AECOM 302.781.5900 tel
Sabre Building, Suite 300 302.781.5901 fax
4051 Ogletown Road
Newark, DE 19713

**Re: Smith Property - Mitchell Homes
Preliminary Land Development Plan**

As requested, we have reviewed the Preliminary Subdivision and Land Development Plan for the above-referenced project. We received the following documents electronically on July 16, 2019:

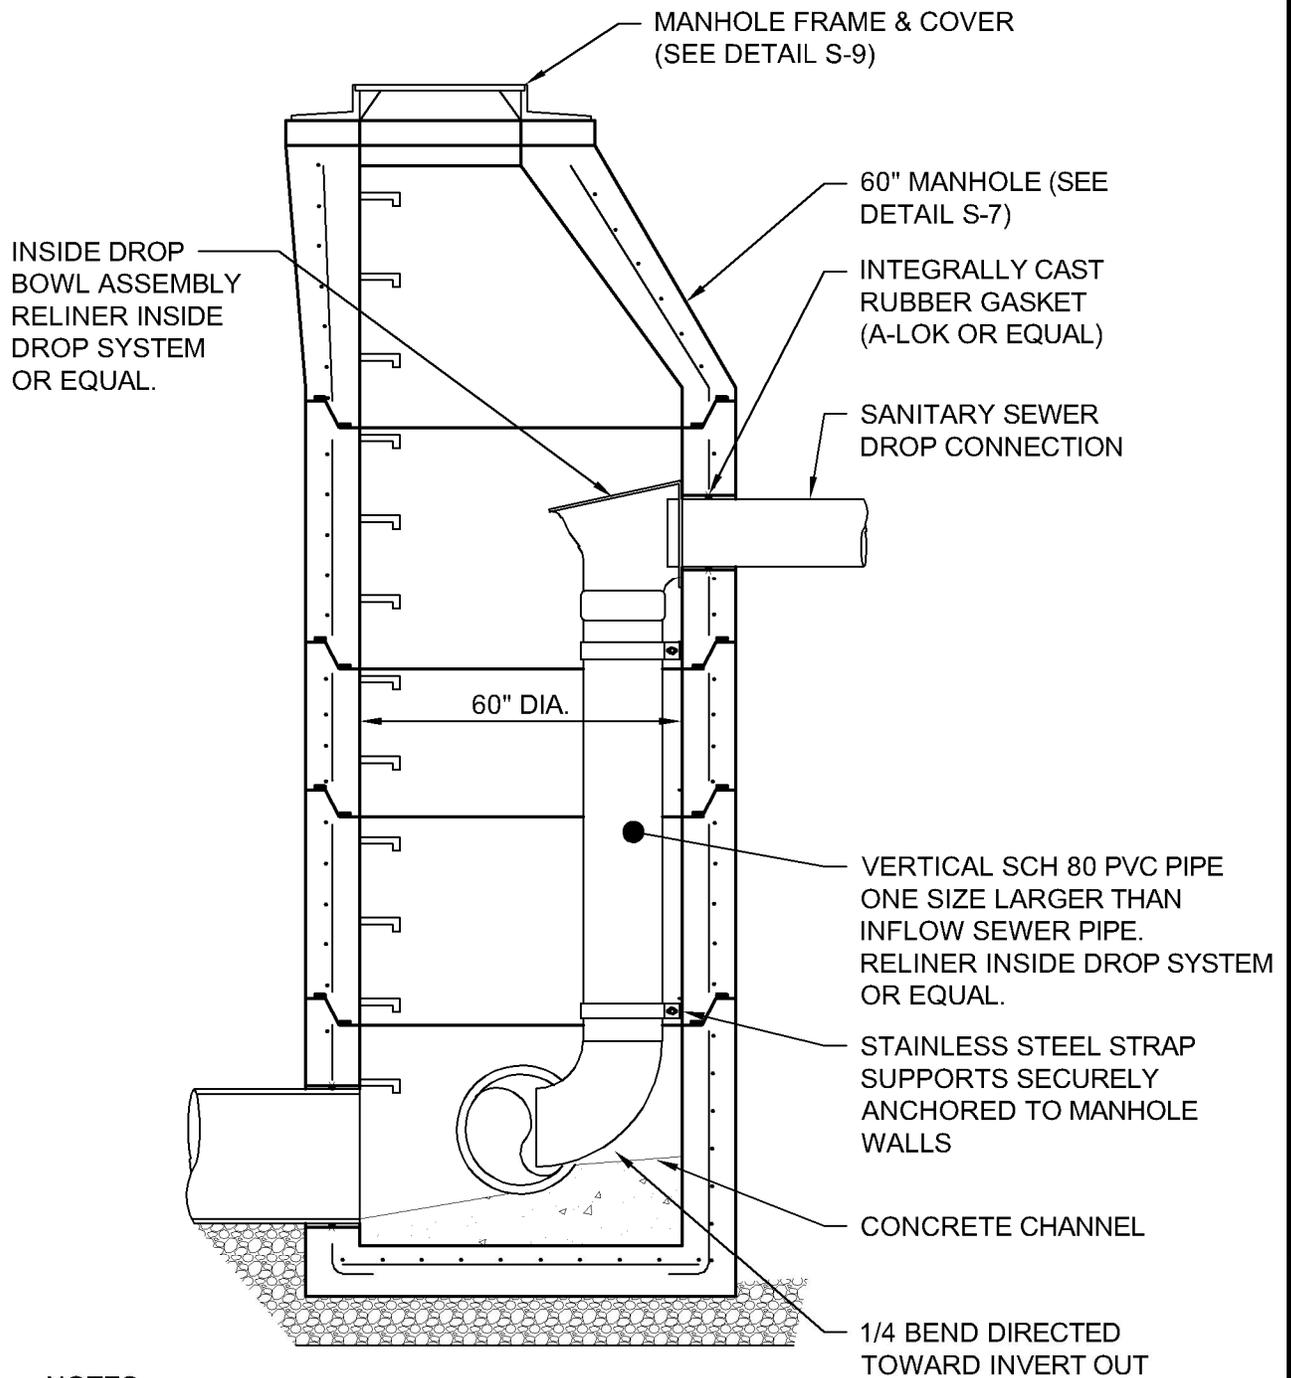
4. The following revisions to drawing C07.2, Profile Sheet, should be addressed:
 - A. Lower the inverts at manholes MHS7 and MHS13 to eliminate the drop manholes. ***The inverts for MHS7 and MHS13 have not been lowered and are still drop manholes. Please lower the invert in elevations and eliminate the drop manholes. This comment remains.***
